LANDMARK COMMUNITY BOARD PRESENTATION

- REMOVAL OF INTERMEDIATE WINDOWS ON MAIN FACADE
- REPLACEMENT OF DOUBLE HUNG WINDOW WITH FRENCH DOOR ON 2ND FLOOR
- CARVED STONE SIGNAGE

PROPOSED REVISION

ENLARGED ELEVATION RENDERING

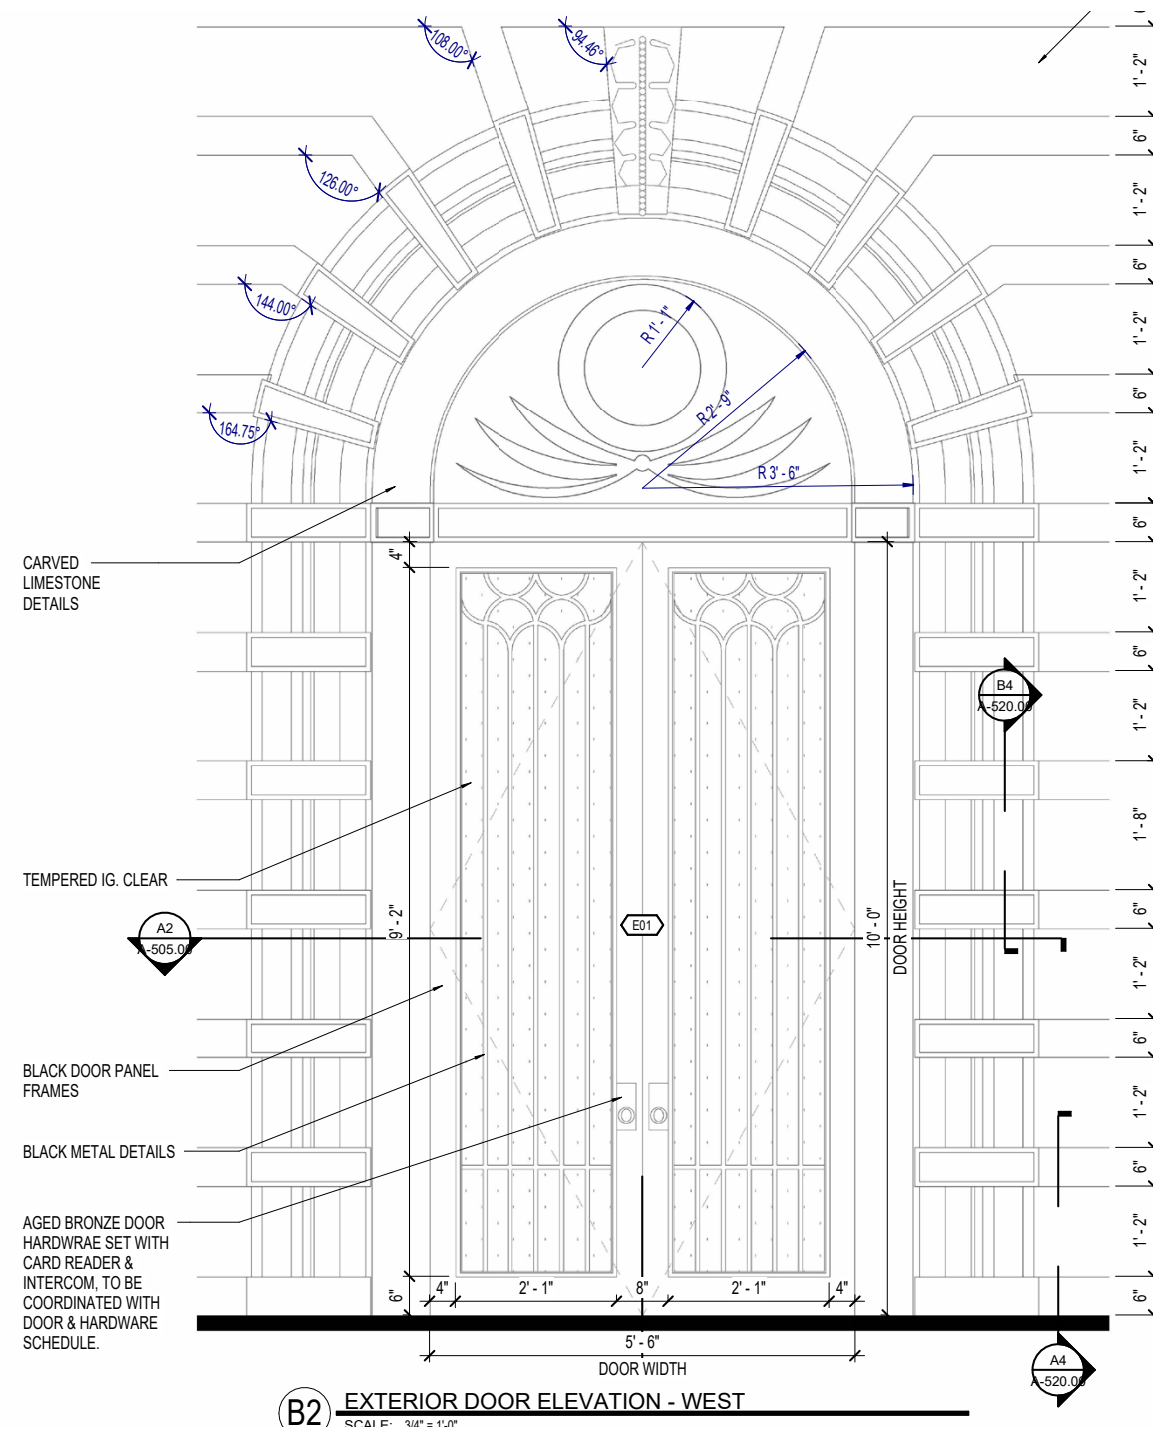
Propose to remove the intermediate windows on the south facade

**REMOVAL OF INTERMEDIATE FIRST FLOOR WINDOWS,
UPDATED ENTRANCE DOOR DESIGN
& ADDED LIMESTONE SIGNAGE**

ENLARGED CARVED LIMESTONE SIGNAGE RENDERING

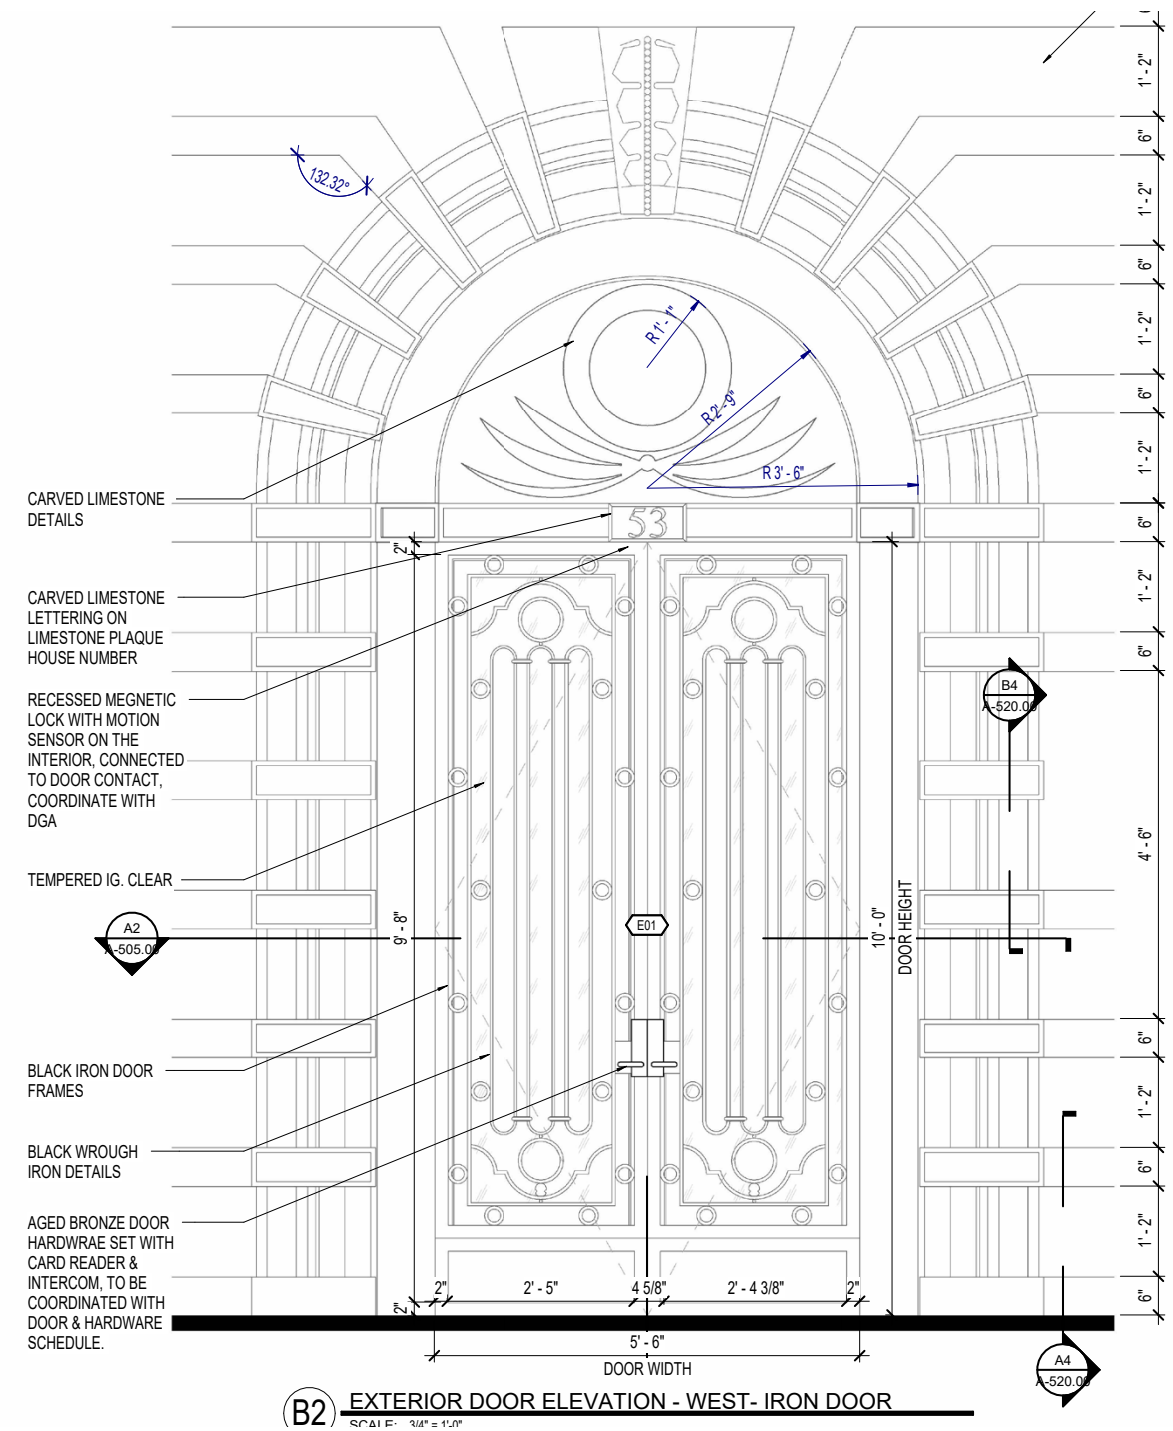
Proposed building name carved in limestone facade

Limstone house number on Imiestone plaque surface mounted on door header

Revised entrance door design
